CRUISER  
AIRCRAFT

## SERVICE BULLETIN

No.: SB-CR-081

<b>MODEL AFFECTED:</b>	PS-28 Cruiser
<b>SUBJECT:</b>	Rudder stops replacement
<b>AIRCRAFT AFFECTED:</b>	All PS-28 Cruiser aircraft.
<b>COMPLIANCE:</b>	According to the respective PS-28 Cruiser aircraft owner's decision.

Fig. 1: Rivets marked to be drilled out

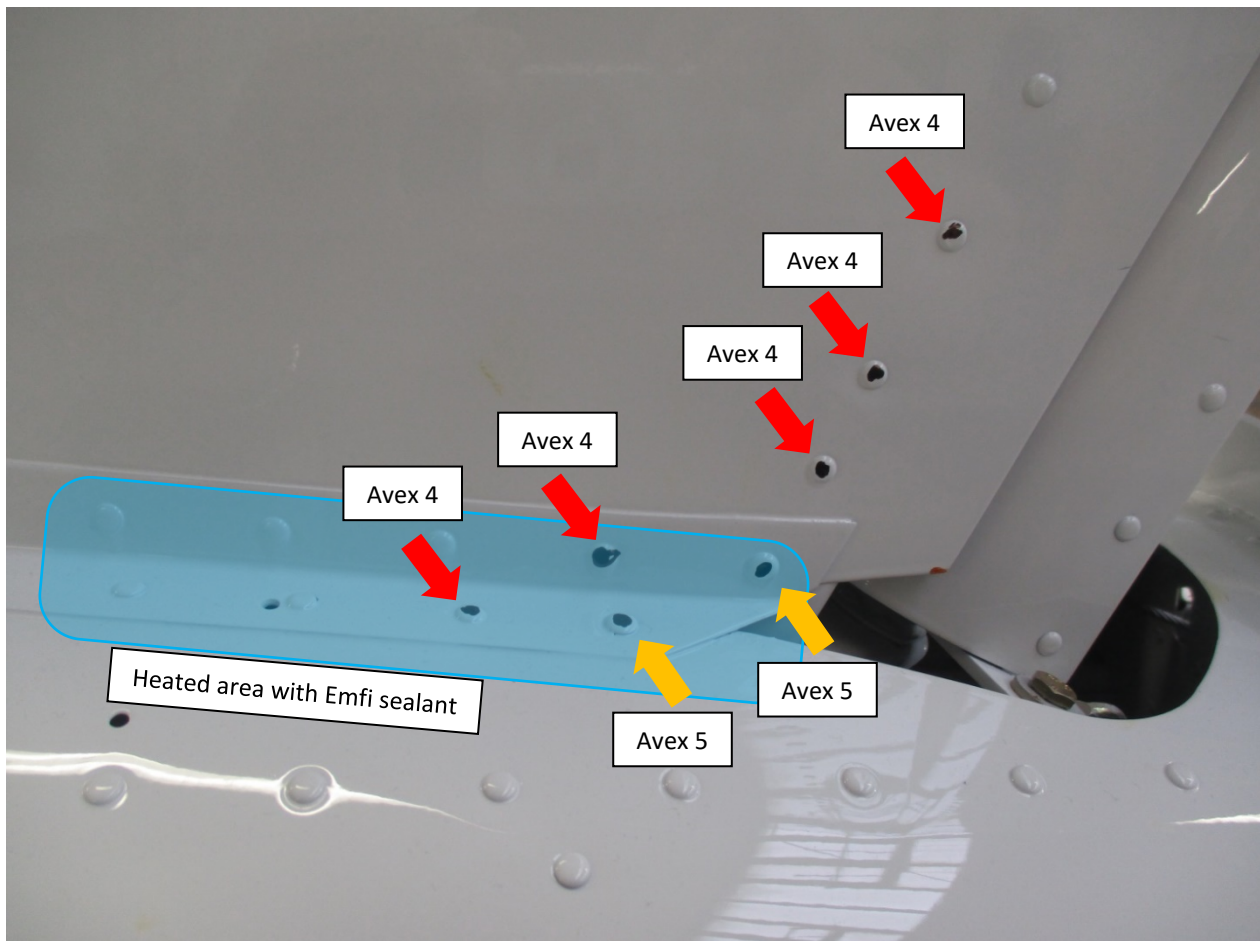
1. Remove horizontal stabilizer (CR-MM-1-0-00, Chap 5.3), disconnect trim wires and elevator rod.
2. Remove rudder (CR-MM-1-0-00, Chap 5.3), disconnect control cables.
3. Drill out the rivets both sides (CR-MM-1-0-00, Chapter 15.2). All drilled rivets are marked on the picture (Fig. 1). Rivets marked as Avex 4 with drill bit D3,2mm and Avex 5 with drill bit D4,1mm.
4. Gently heat up the fairing with a hot-air gun in blue area.

8. Install the left and the right stop, keep stops in contact with the mounting device.
9. Drill the holes, D3,2mm for Avex 4 and D4,1mm for Avex 5, see Fig. 1.

13. Gradually rivet (CR-MM-1-0-00, Chap 15.3) the rivets Avex 4-10 pcs. and Avex 5-4 pcs. See Fig. 1.
14. Remove the mounting device.
15. Clean the airframe from rest of rivets.

**Fig. 2:** Mounting device

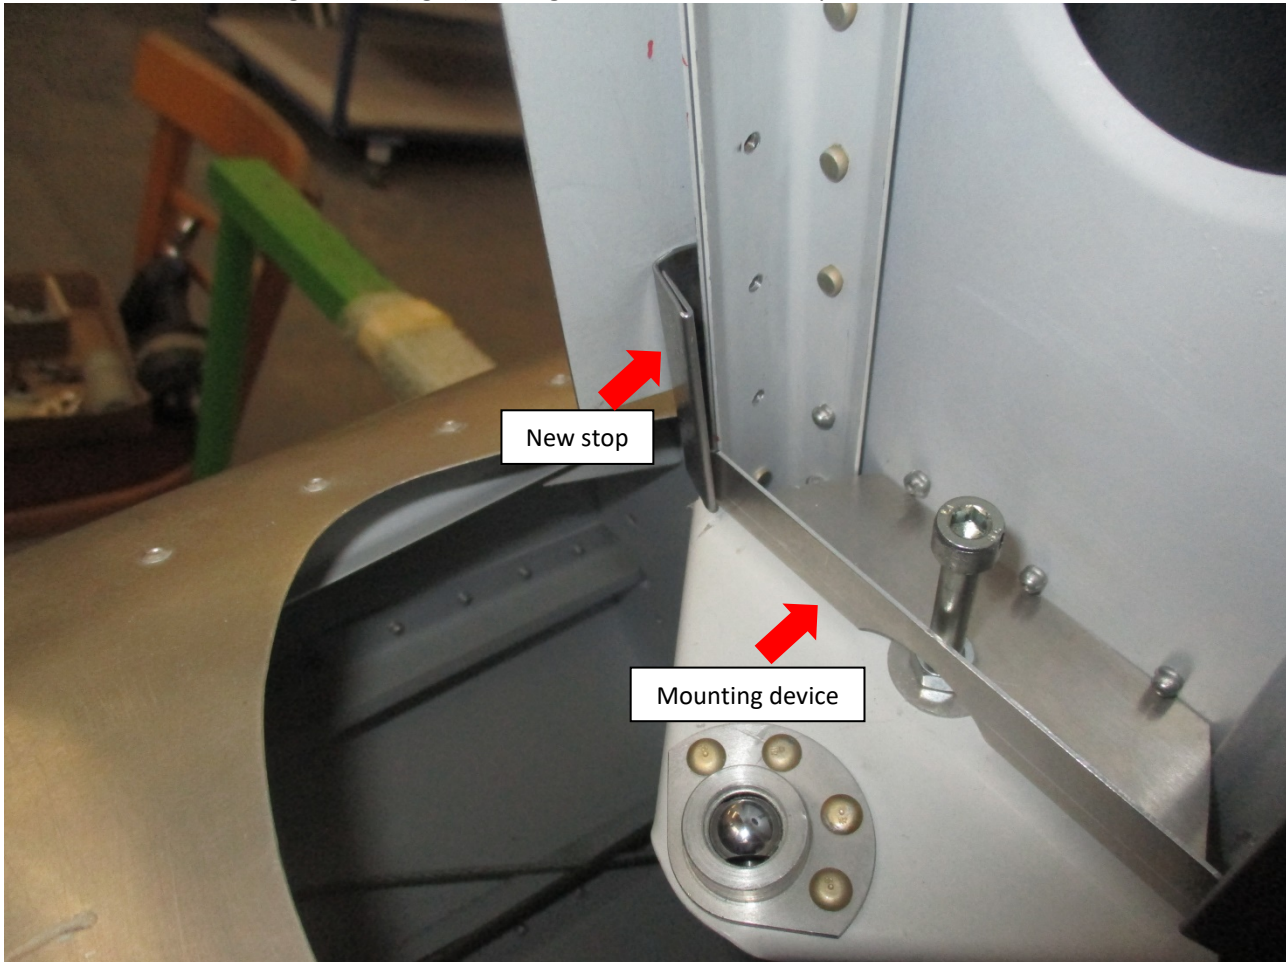
5. Remove the stops.
6. Remove any residual Emfi sealant using a snap blade knife.
7. Install the mounting device (Fig. 2) for alignment of the new stops CF0262LP.
